# UNITED STATES PATENT AND TRADEMARK OFFICE

APPLICATION NO.	FILING DATE	FIRST NAMED INVENTOR	ATTORNEY DOCKET NO.	CONFIRMATION NO.
10/577,921	12/15/2006	Katsura Koyagi	290692US3X PCT	6877

<b>Office Action Summary</b>	<b>Application No.</b> 10/577,921	<b>Applicant(s)</b> KOYAGI ET AL.	
	<b>Examiner</b> William C. Joyce	<b>Art Unit</b> 3656

### **DETAILED ACTION**

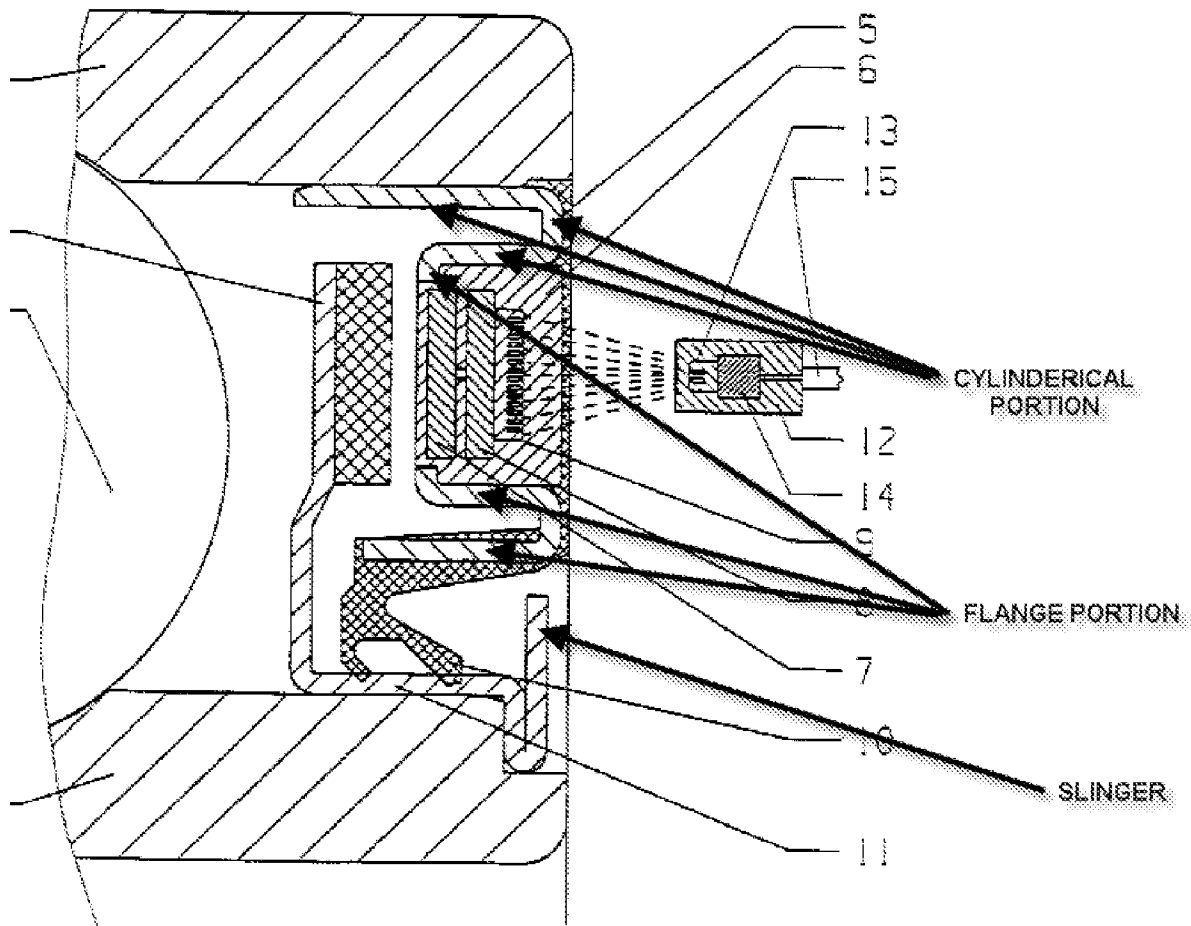
Hofmann discloses (Fig. 1) a sensor-equipped seal device comprising a fixed-side seal member (5) having a core fixedly fitted to a fixed member (1) and a sensor (7) attached to the core by a molded resin, and a rotation-side seal member (11) having a slinger (see labeled figure below) fixedly fitted to a rotating member (2) and a pulser (4) secured to the slinger, wherein the core of the fixed-side seal member has a cylindrical portion (see labeled figure below) fixedly fitted to the fixed member, and a flange (see labeled figure below) extends from an axially inner end of the cylindrical portion toward the rotation-side seal member, wherein the sensor is positioned radially inward of the cylindrical portion of the metal core and axially outward of the flange of the metal core so that no metal portion exists between the sensor and the pulser, and wherein a labyrinth seal is provided between an outer peripheral edge portion of an outward flange of the slinger of the rotation-side seal member and a resin member formed by the molded resin, the flange being provided with an elastic seal (10) slidable in contact with the rotation-side seal member, the core of the fixed-side seal

member is provided by molding so that an outer end of the cylindrical portion is positioned within the resin, the rotation-side seal member is provided with a lip support comprising a cylinder fixedly fitted to the slinger and a flange integral with the cylinder and axially outwardly opposed to the pulser from an axially inward position for supporting a lip portion of the elastic seal.

With respect to claims 8 and 9, Hofmann illustrates the sensor positioned closer to the pulser than is any portion of the metal core of the fixed side seal member.

Applicant argues Hofmann et al. does not disclose the sensor positioned radially inward of the cylindrical portion of the metal core and axially inward of the flange of the metal core. Referring to the figure above, Hofmann et al. teaches the sensor positioned radially inward of the cylindrical portion of the metal core. With respect to the axial positioning of the sensor, please refer to the claim rejection under 35 USC 112, 2nd paragraph.

Again referring to the above figure, Hoffmann et al. illustrates the labyrinth seal being positioned as claimed.
